**Comments of Powerex Corp. on
EIM Greenhouse Gas Enhancement
Draft Final Proposal**

Submitted by	Company	Date Submitted
Mike Benn 604.891.6074	Powerex Corp.	July 6, 2017

Powerex appreciates the opportunity to submit comments on CAISO’s May 24, 2017 EIM Greenhouse Gas (“GHG”) Enhancement Draft Final Proposal (“Draft Final Proposal”) and the Revised Final Proposal of June 23, 2017.

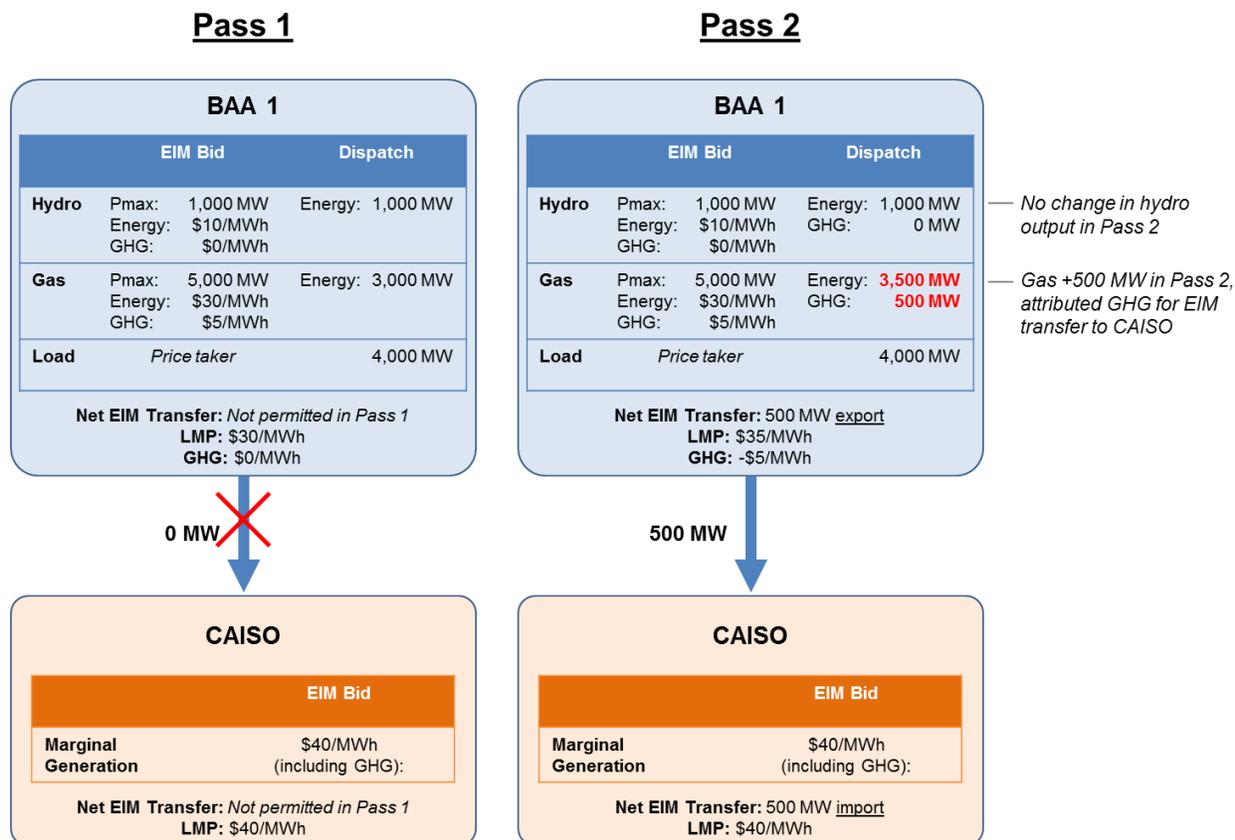
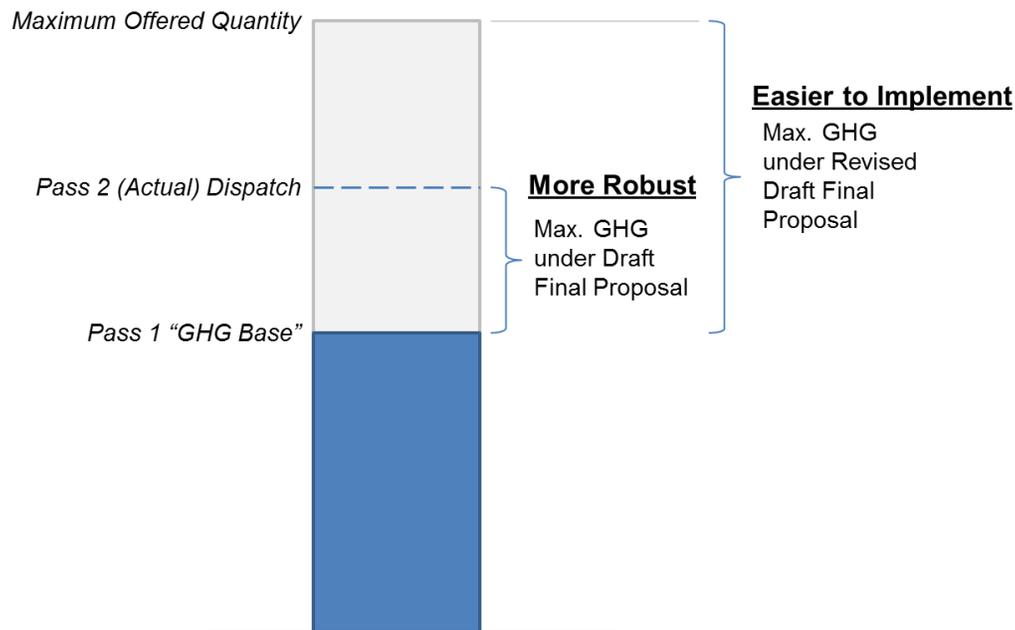
Under the proposed two-pass solution, the outcome from the above example would be starkly different. The “first pass” would simulate the EIM market outcome if there were no EIM transfers serving load in California. The solution in this “first pass” would consist of 1,000 MW of hydro and 3,000 MW of gas generation, and is shown on the left-hand panel, below. In the “second pass,” which is also the actual market dispatch, the result is the same as above, (*i.e.*, 1,000 MW of hydro; 3,500 MW of gas; and 500 MW of EIM transfers serving California load). The right-hand panel, below, shows this “second pass” solution, with the change between the first and second pass highlighted in red:

The two-pass solution reveals that, when EIM transfers serve load in California, it is the *gas-fired generation* in BAA1 that increases its output and GHG emissions. Under this framework, the EIM algorithm would attribute the EIM transfers serving load in California to 500 MW of output from the gas generators in BAA1, not to the hydro resources. The final market solution in this case would be: LMP in the CAISO BAA of \$40/MWh; LMP in BAA1 of \$35/MWh; and a GHG shadow price of \$-5/MWh. The gas-fired resources in BAA1 would be required to report to CARB 500 MW of specified-source deliveries to California, and procure and surrender the corresponding quantity of GHG emission allowances.

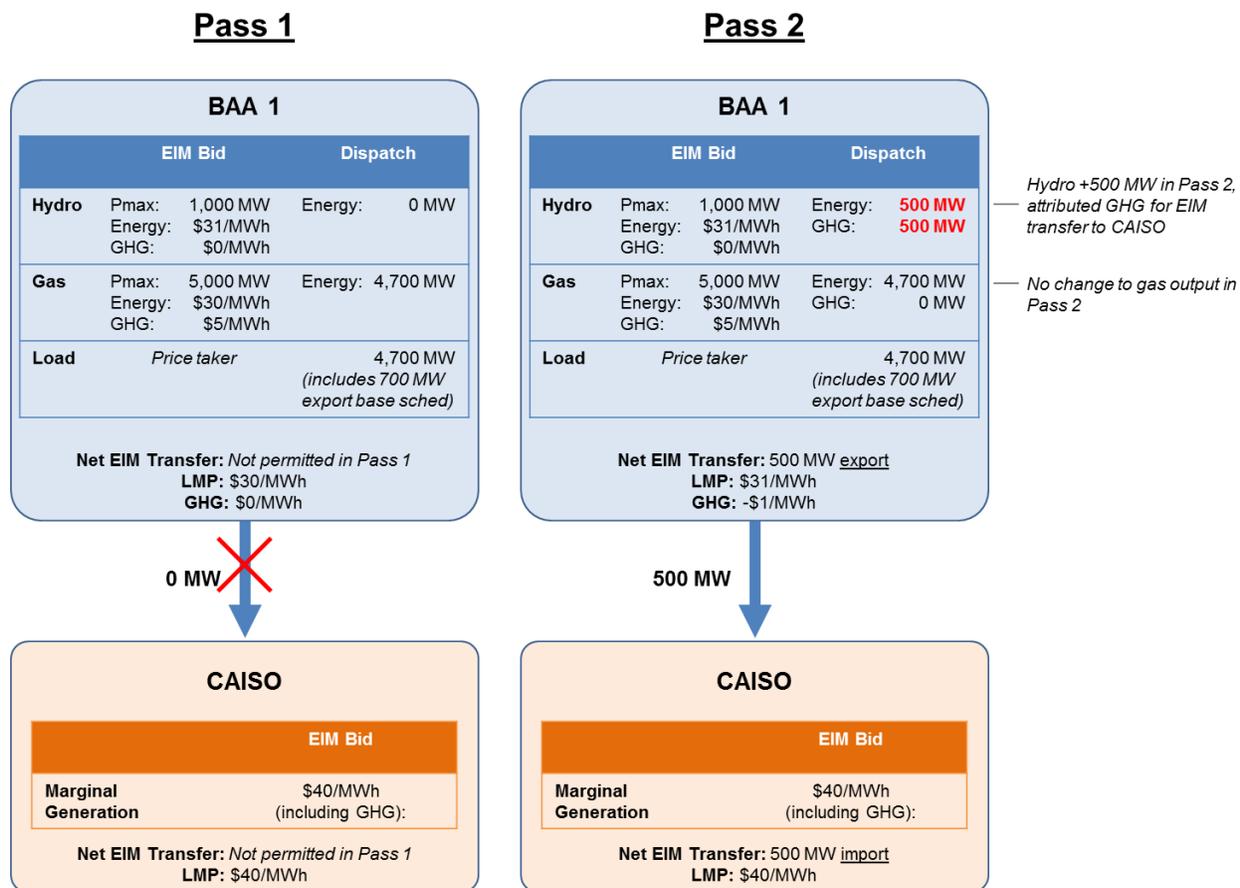
This can be seen by extending the prior example to include a wind farm with expected output of 200 MW. The result of the “first pass” is shown below, on the left-hand side. The wind and hydro resources with zero bid-in cost are obviously part of the least-cost solution, with the additional energy needed to meet forecast demand in BAA1 obtained from the gas resources. The “second pass” result, which is also the actual market result, is shown on the right-hand side. As before, permitting up to 500 MW of EIM transfer to serve California load results in a 500 MW increase in the output from gas-fired resources in BAA1. California load is therefore attributed to gas-fired generation in BAA1.

No change to wind output in Pass 2

No change to hydro output in Pass 2

Gas +500 MW in Pass 2, attributed GHG for EIM transfer to CAISO

It is undeniably true that the wind resource in BAA1 “would have run anyway,” even with no EIM transfer serving California load. However, it is likewise true that the resource would not even exist—and hence would be entirely unavailable—had it not been for the RPS contract to a California load-serving entity. In order to recognize that California loads are being served by the out-of-state renewable energy facility they have funded, it appears appropriate to provide a limited alternative “by-pass” to the two-pass framework for such facilities.⁶ This appears to be one of the objectives of the Draft Final Proposal’s “California supply” functionality.
